Re: *Addendum No. 1
JR Smith Park Improvements
City of Sunbury, OH*

Date: December 8, 2025

**Proposal to City of Sunbury
For JR Smith Park Improvements
Base Bid - Site Improvements
Project No. 0000041545**

P201

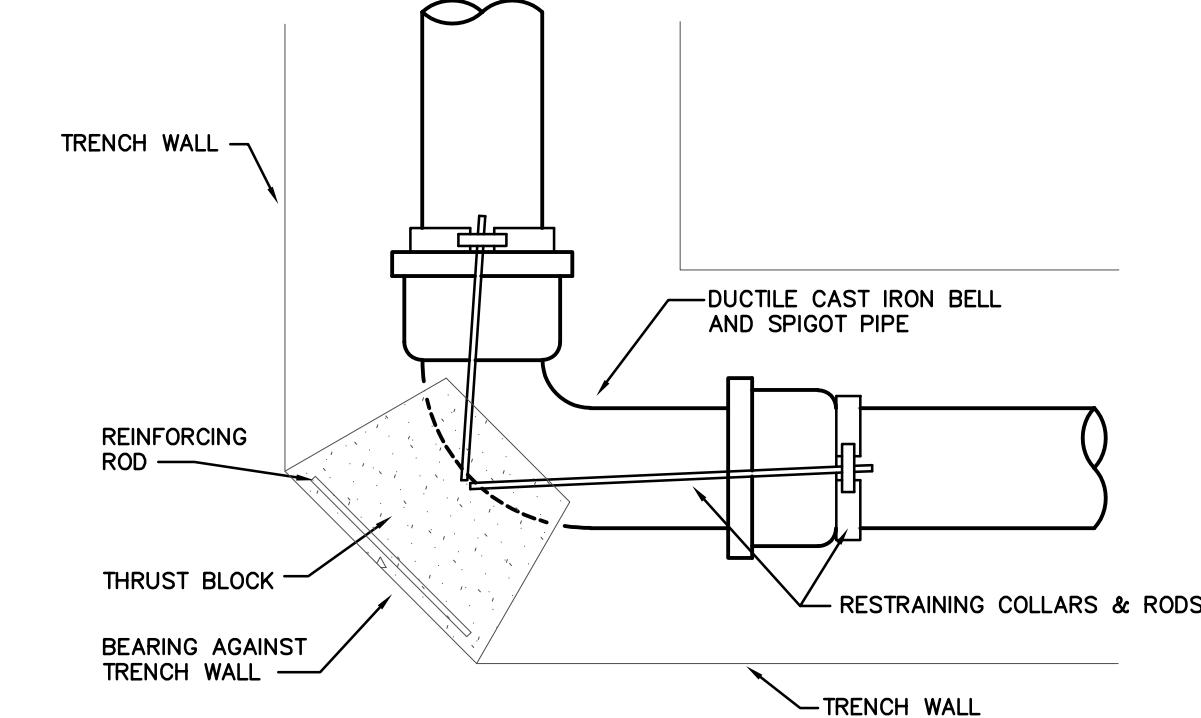
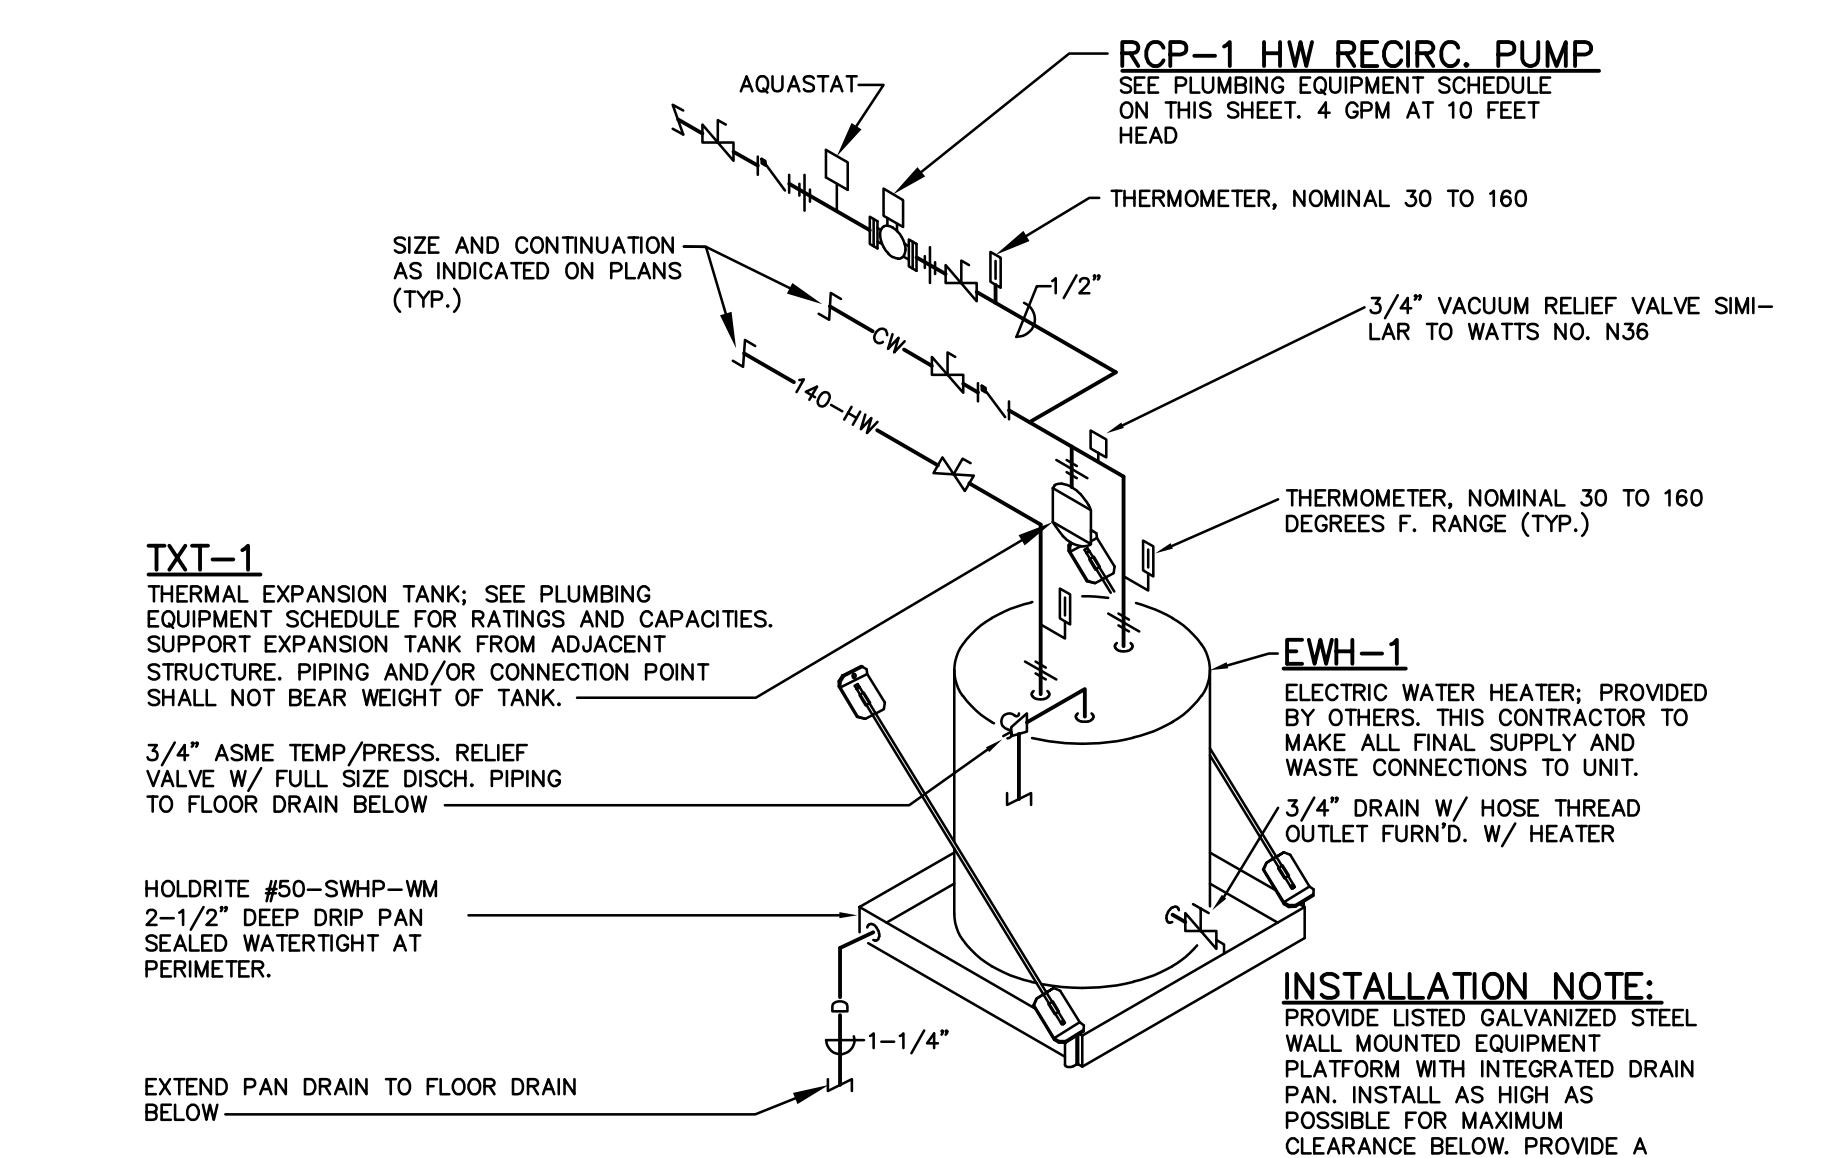
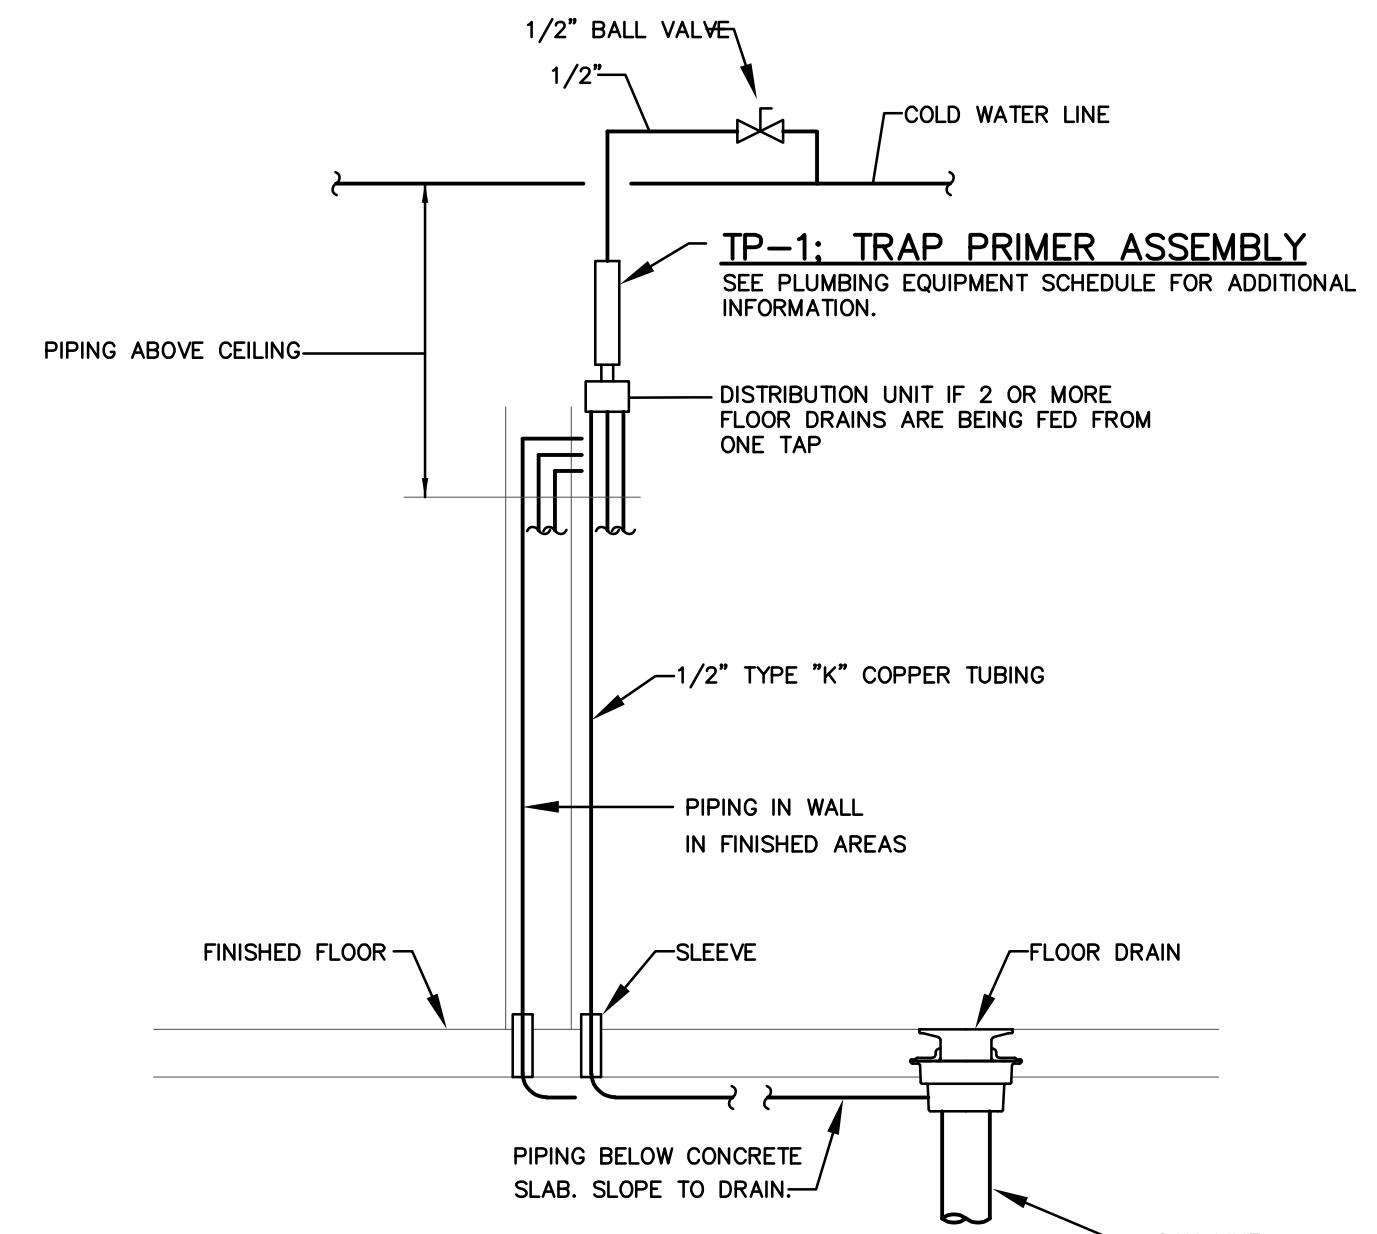
Q12 Can you provide specs for the UR-01, HB-1, FD-1, FCO & WCO in the building plans?

A12 Refer to the enclosed Revised plan sheets P101 and P201.

Replace plan sheets E100, P101 and P201 with the enclosed Revised per Addendum 1 plan E100, P101 and P201.
